In reply, please quote:
Twin Creek wind farm

14 February 2024

The Bureau has carried out a technical assessment of the potential effects of the proposed Twin Creek wind farm development on the Adelaide (Buckland) weather radar, located 62 km northeast of the proposed development.

Twin creek wind farm - EMI Assessment WR 679

Figure 1

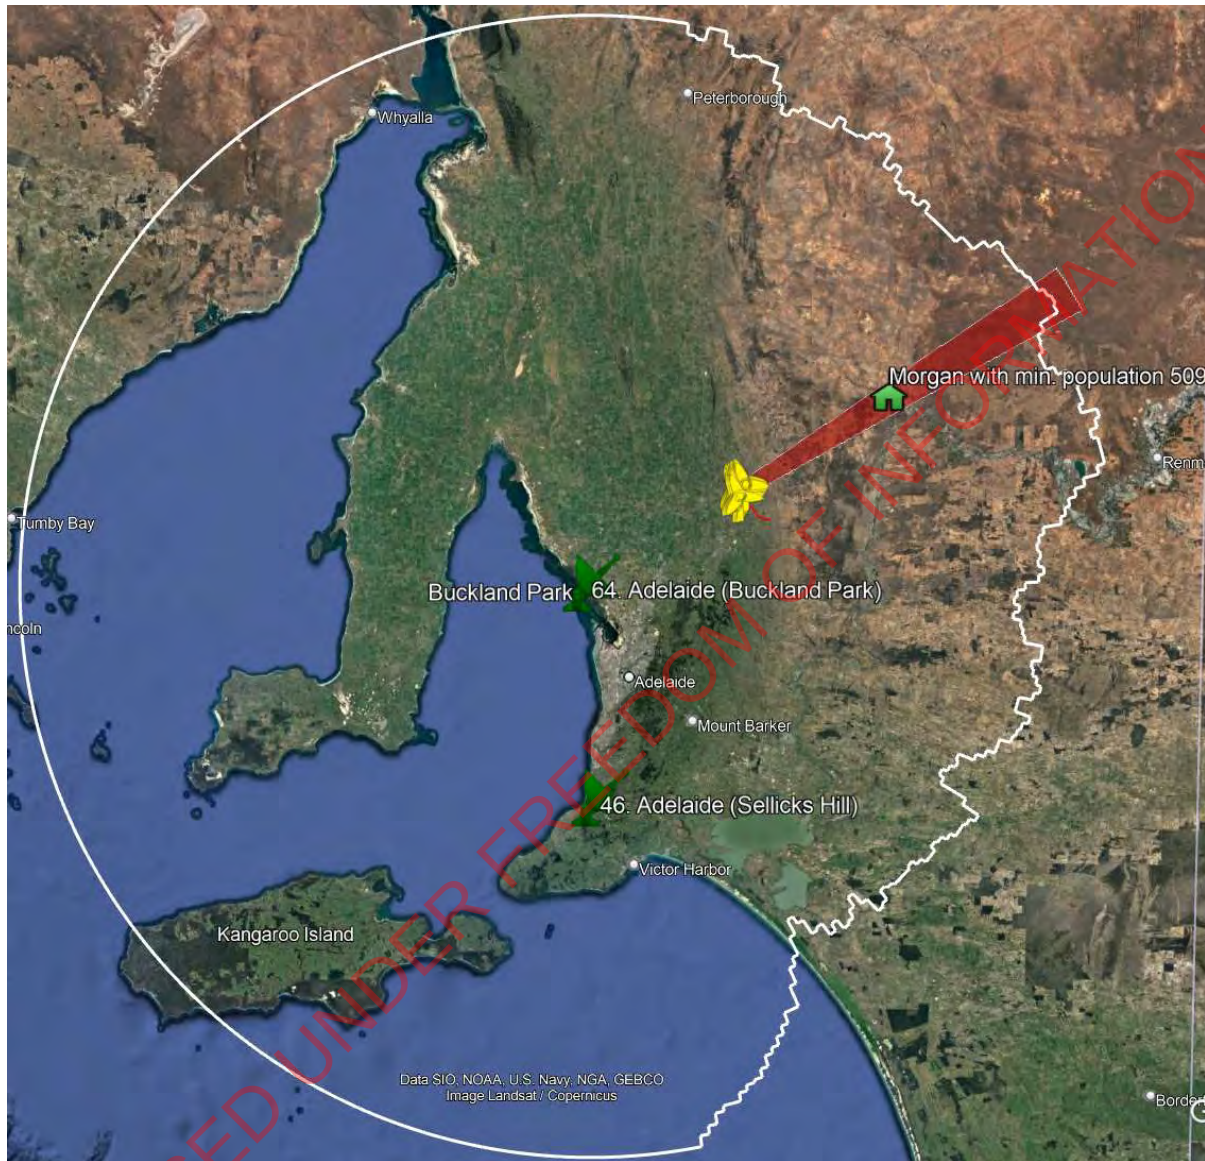
- The proximity to a meteorological radar that serves a capital city (Adelaide),
- Turbines with a 220 m tip height will potentially affect a segment of the Adelaide radar,
- The Morgan township, with a population of around 500, lies behind the Twin Creek wind farm and will most likely lose weather radar coverage from the Adelaide (Buckland Park) radar (Figure 1).

- East side of the wind farm, "downstream" of the radar (Figure 1), in the area around and to the east of Morgan, we recommend the installation of rain gauges, and automatic weather stations (AWS), with precise numbers and locations to be determined.
- West side of the wind farm towards Adelaide, we also recommend the installation of rain gauges and automatic weather stations, with precise numbers and locations to be determined.

Figure 1 shows the existing coverage from the Buckland Park radar in the area enclosed by the irregular white circle. The red shaded sector shows the area in which radar coverage will be impaired by the installation of wind turbines at Twin Creek. The green house icon indicates the location of the Morgan township, being approximately 70 km from the Twin Creek development.

Adelaide (Buckland Park) Denial

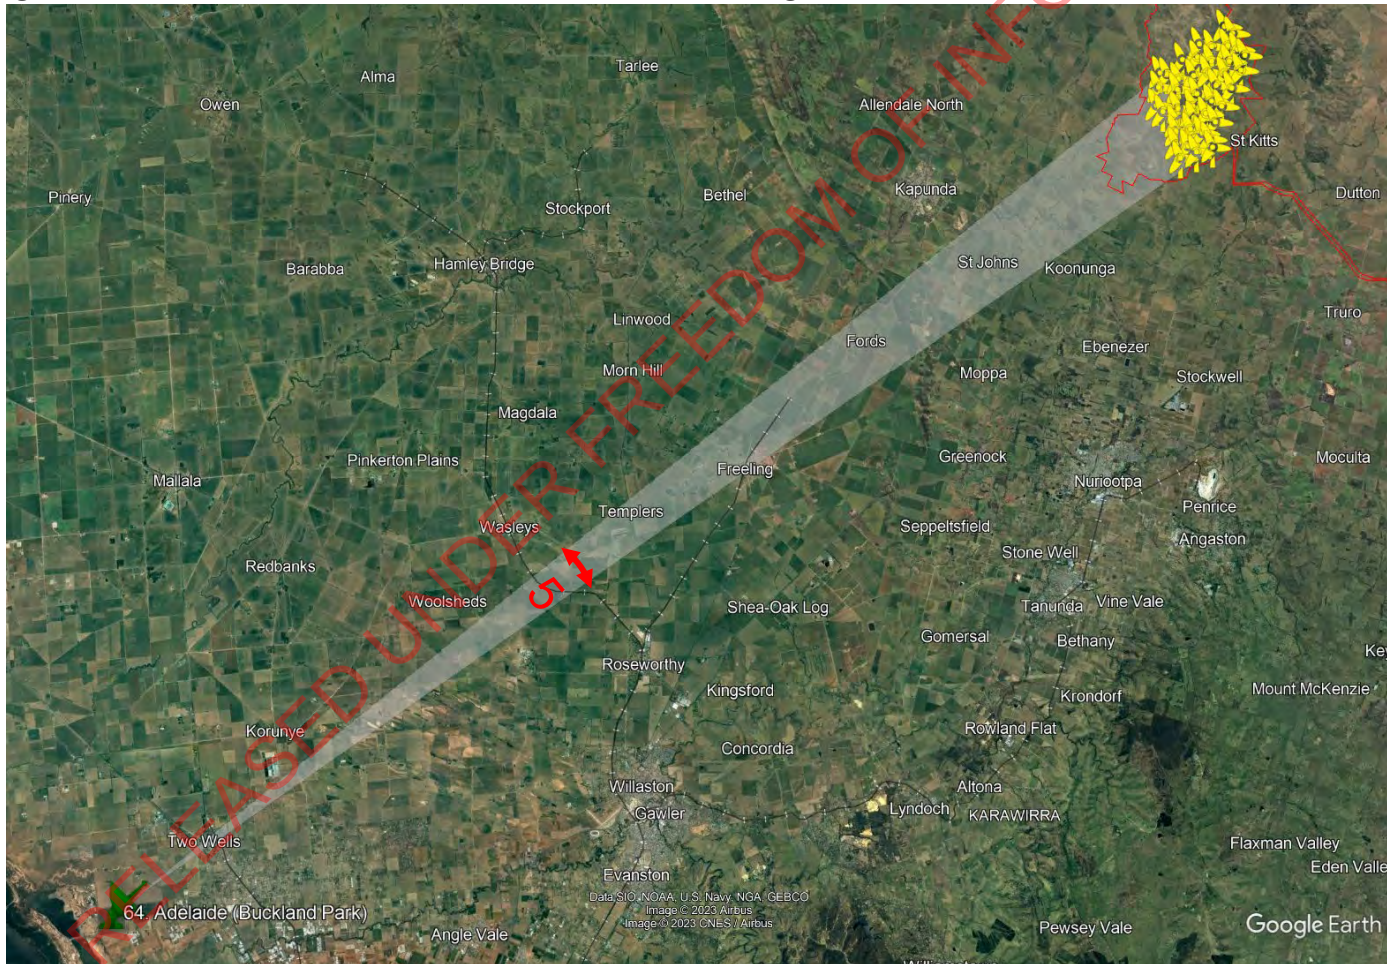
- Existing at 62 km in radials between 56 – 61 deg around Buckland Park radar.

Buckland park – 3dB-beamwidth contamination

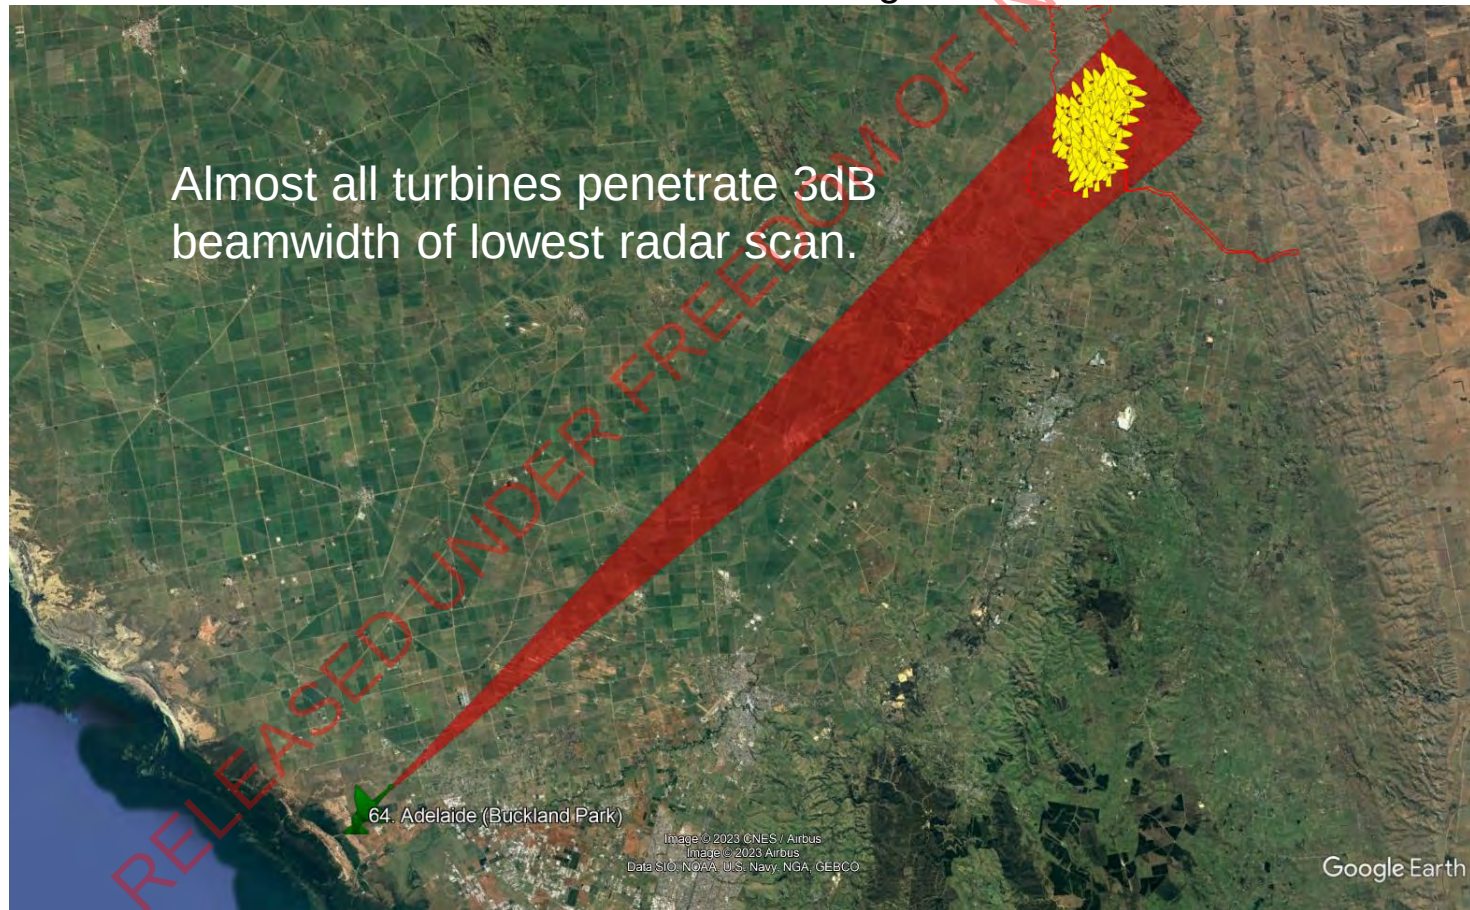
- 3dB Beamwidth contamination of first scan: 0.5 deg.

Buckland park – Power-level simulations

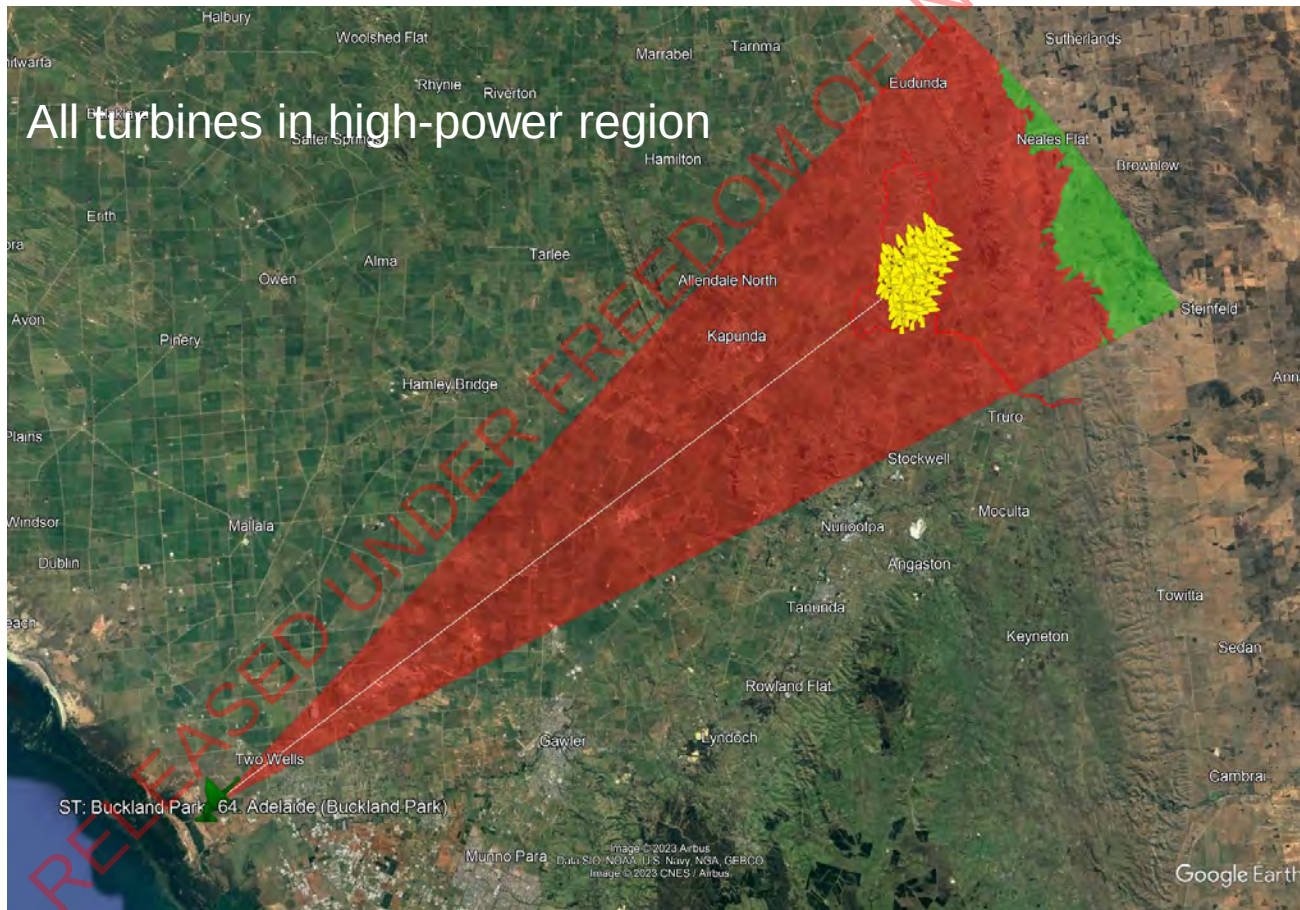
- First 0.5 deg Scan: Power Threshold -45 dBm (red shaded > -45 dBm)

Buckland park – Power-level simulations

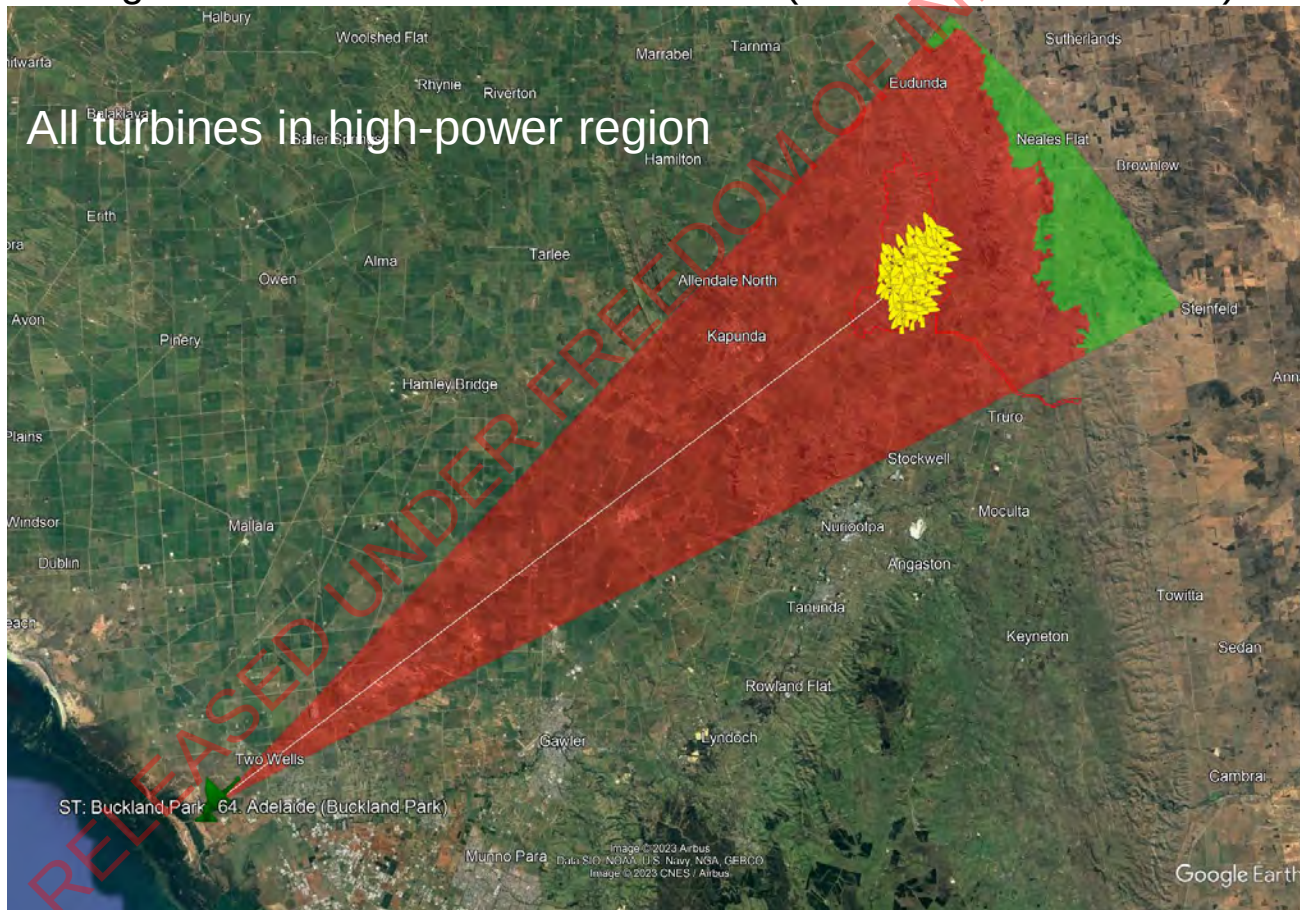
- Second 0.8 deg Scan: Power Threshold -45 dBm (red shaded > -45 dBm)

Buckland park – Power-level simulations

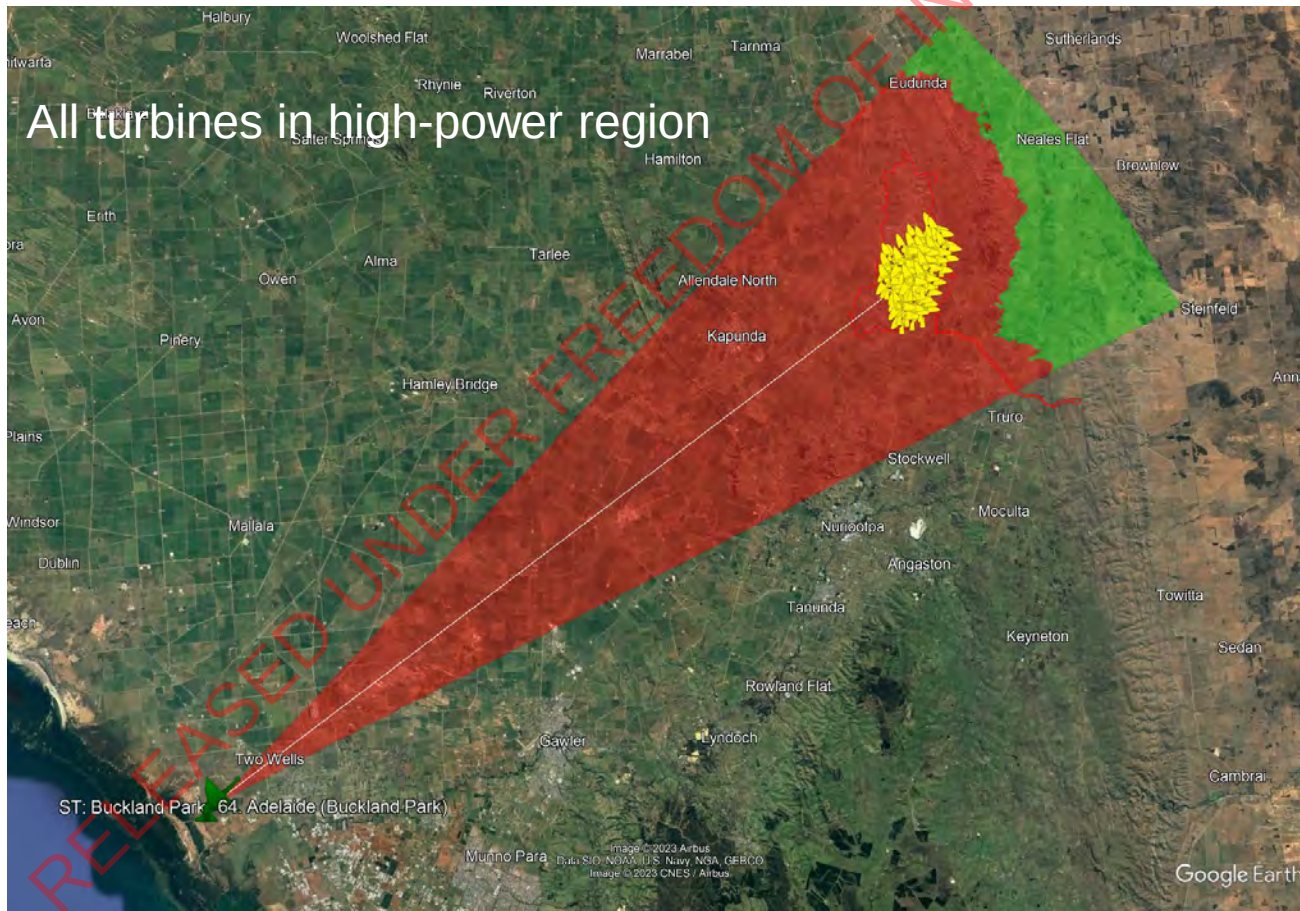
- Third 1.4 deg Scan: Power Threshold -45 dBm (red shaded > -45 dBm)

Selicks Hill – 3dB-beamwidth contamination

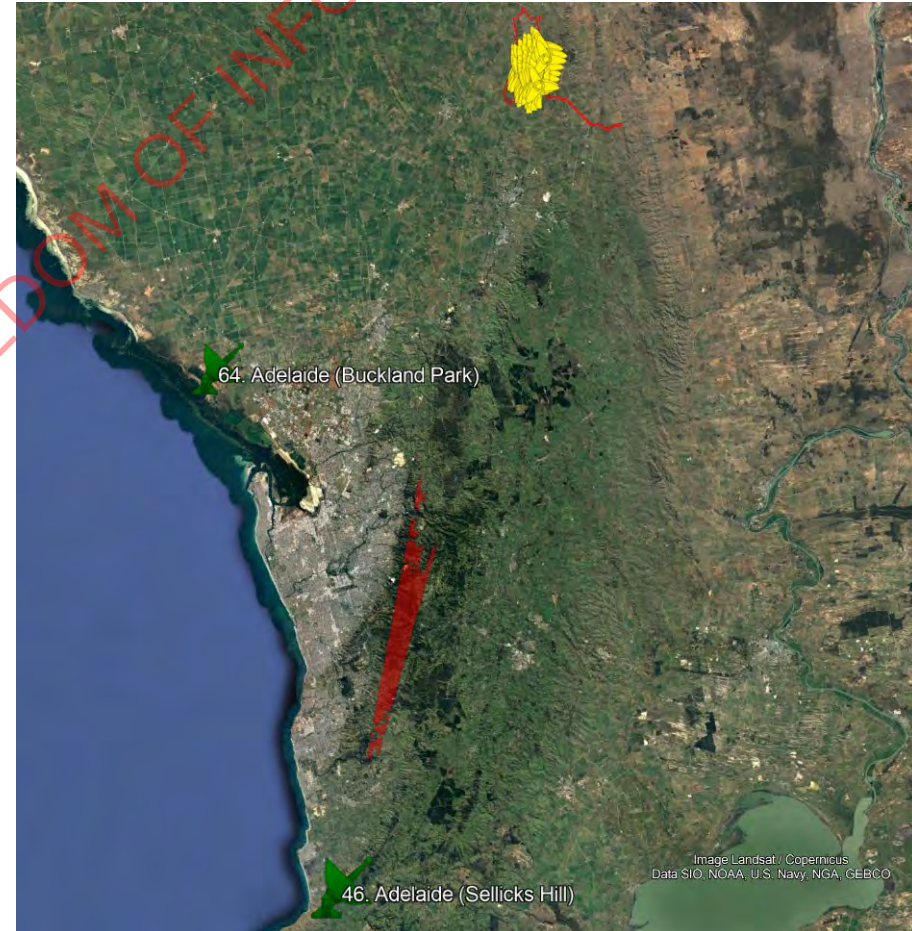
3dB Beamwidth contamination of lowest scan: 0.8 deg

- Turbines of the proposed wind farm are not within 3dB beamwidth of the radar's lowest beam.

Selicks hill – Power-level simulations

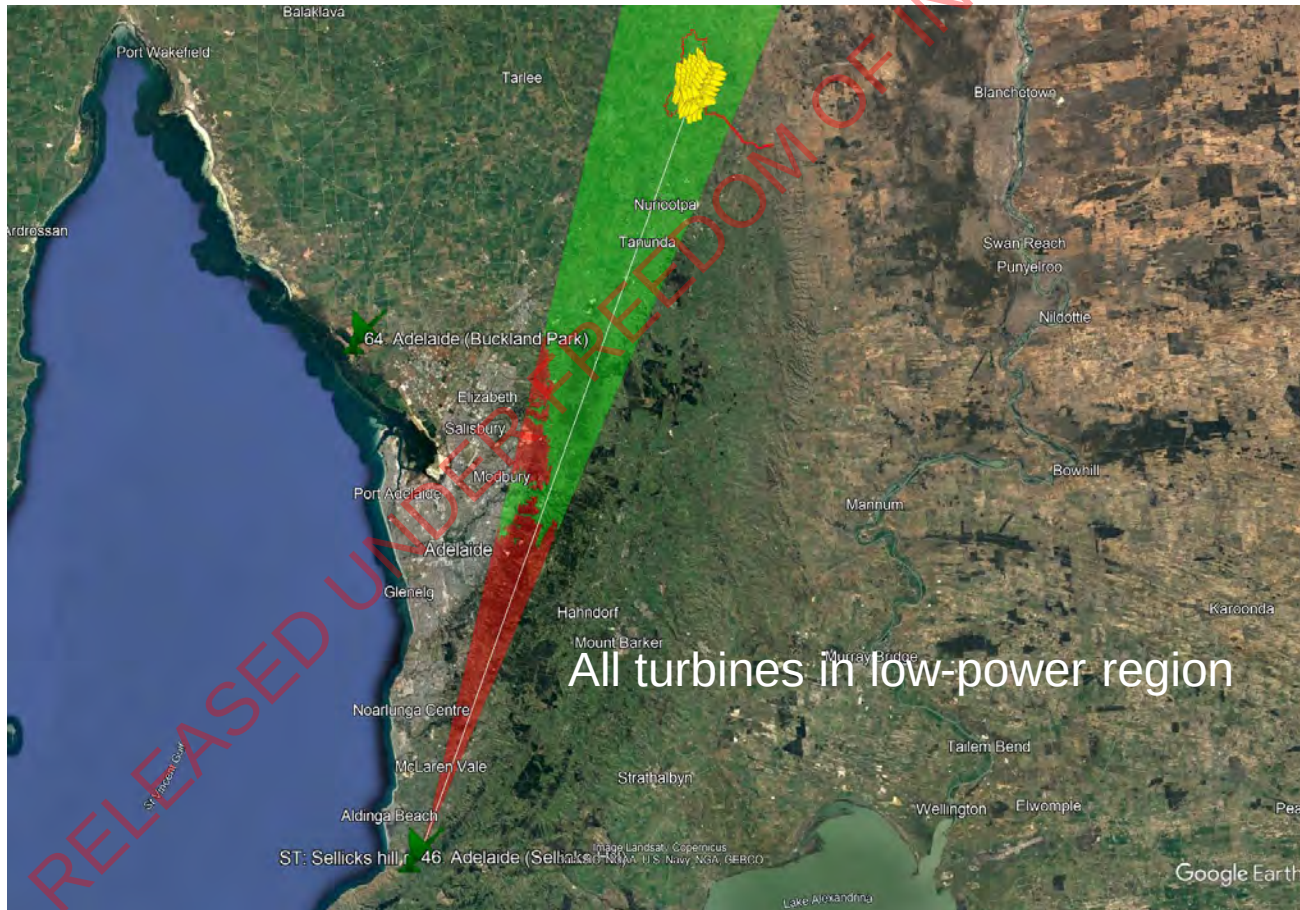
- First 0.8 deg Scan: Power Threshold -45 dBm (red shaded > -45 dBm)
